Subject: Objection to the "Creation of a Wildlife Feature" as identified in PL/202506176

Re: Planning Application PL/2025/06176

Page 5, Figure 3 Holding and Catchment map including sediment pathways

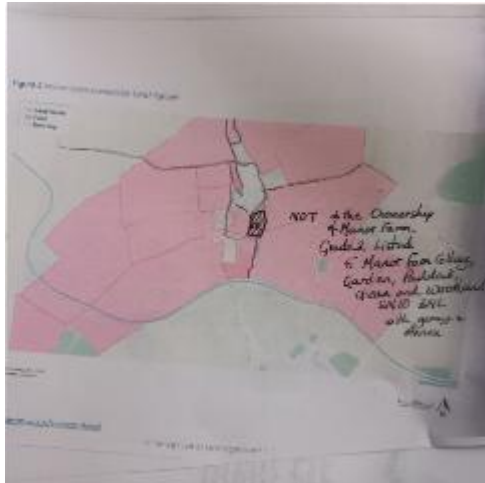
The Catchment Impact Report, states that "The River Gog catchment is approximately 260 hectares and lies entirely within the boundary of the Manor Farm Estate" this statement implies, in my opinion, that there are no other landowners, nor property owners, within this 260 Hectares which of course is untrue.

There is an ADJOINING landowner, upstream, with a GRADE 2 listed property, that has been totally disregarded in all aspects of this Planning Application.

Page 4, Figure 5 Identifies Manor Farm Ownership, Land Parcels in red.

Grade 2 Listed, No. 5 Manor Farm Cottage, Gardens, Paddock, Stream and Woodland that ADJOIN the Applicants property, upstream from the "Water Feature" have been totally omitted.

Please Note, that the Ownership of the adjoining property to the North has been totally omitted.

Nor any inclusion of the Grade 2 Listed Dwelling, nor my Annex.

Amendments made to diagrams identified in the **Flood Risk Management Report, Page 4 and 5, Appendix 1 and 2**

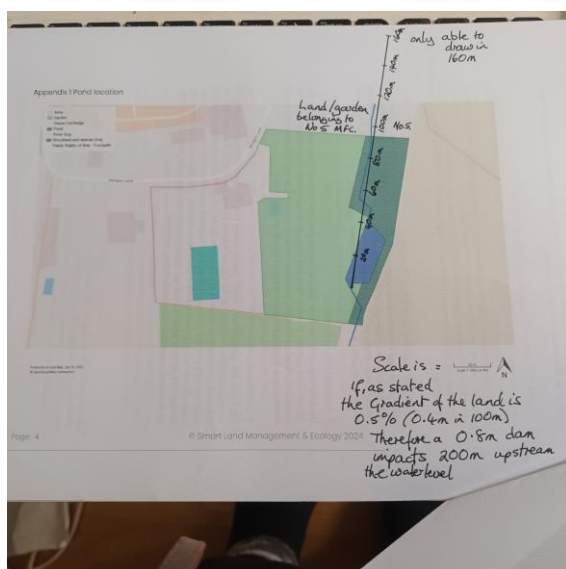
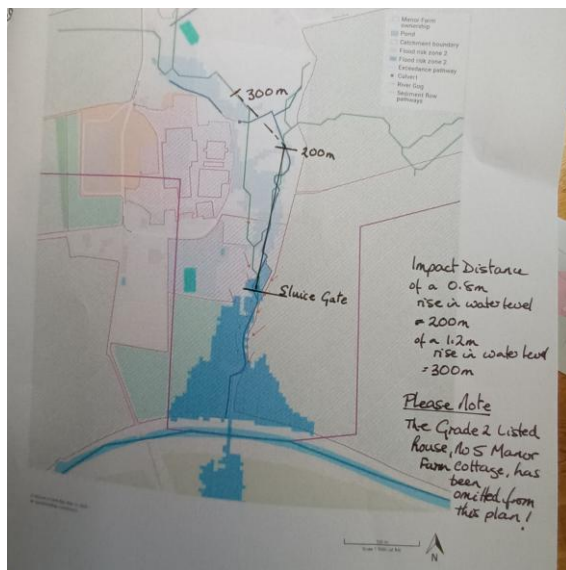
Report states that there is a "Consistent fall of 0.5% (0.4 m per 100m) through the garden."

A very low gradient.

BUT, a gradient that is applicable UPSTREAM as well.

IF the sluice creates a POND depth of 0.9 m, then one could expect, with their landfall data, that the impact of their pond would reach over 200 m upstream.

an increased stream height of 1.2 m affects 300 meters upstream in a normal, non flood situation.

These 2 diagrams, to scale, demonstrate the UPSTREAM impact of a rise in stream level. The impact extends for 200 m or possibly 300m if the Concrete Barrier supporting the gate acts as a Dam itself.

The Impact of a 0.8 m Sluice gate (the stated is 0.9m) is 200 m - by the presented data.
300m if the level rises to 1.2m

Image 5

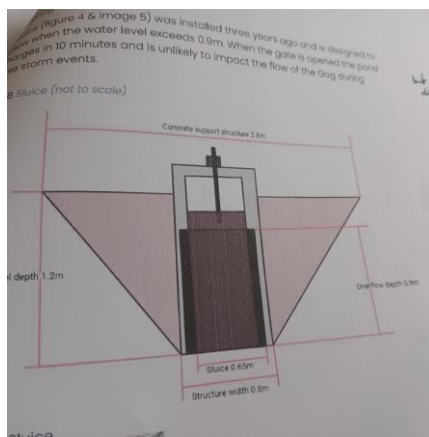
If the stream water is held back by the DAM that has been created by the concrete structure, to support the sluice gate, seen in the **Catchment Impact Report, Engineering Works, page 13, Figure 8**, where there does not seem to be any capacity to release the water flow, apart from manually lifting the sluice gate to open a 0.65m wide channel at the base of the gate where the sludge will be building up or the 'natural overflow' that is already demonstrated as occurring at a greater than 0.9 m height - their diagram demonstrates this.

Their photograph, Image 5, shows a different view. It shows a 1.2 metre concrete structure across the stream, and behind the sluice gate.
